21 September 2011

## PROPOSED TONKIN HIGHWAY/MORLEY DRIVE INTERSECTION CLEARING MAY BE AT VARIANCE WITH CLEARING PRINCIPLE 'E'

Figure 2 Aerial photograph of project area

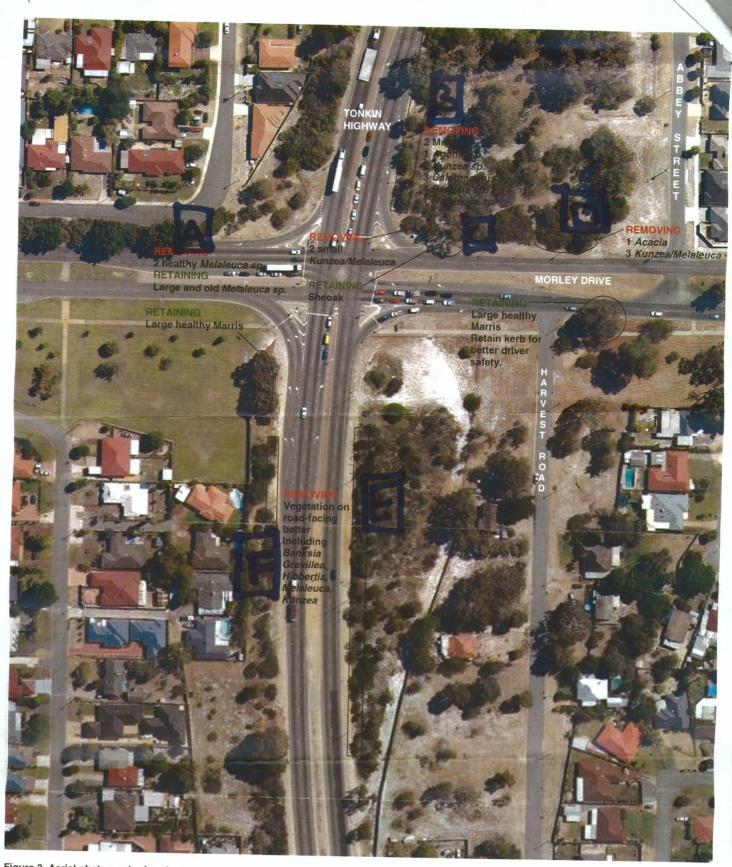
Based on the plans provided to the City, it is noted that the proposed vegetation clearing in some areas seems to be excessive and does not appear to be required as part of the road widening.

Furthermore, the removal of vegetation in these areas will reduce or completely remove the vegetative buffer to the nearby properties which potentially could lead to noise concerns. Accordingly, in the areas where widening is occurring, the City would recommend vegetating adjacent to those areas to provide some noise attenuation.

Section A: The road widening does not enter the vegetation areas and the City recommends trimming this vegetation rather than removing;

Section B: As Per Main Roads Recommendation;

Section C: As Per Main Roads Recommendation;

Section D: The plans do not show that the vegetation impacts the road widening and the City recommends retaining the vegetation;

Section E: Widening does not impact vegetation and the City recommends trimming the vegetation to provide necessary clearance and further planting to provide a noise barrier to the adjacent properties; and

Section F – Where needed, remove vegetation and further revegetate adjacent to the road widening area to provide noise attenuation to nearby properties.
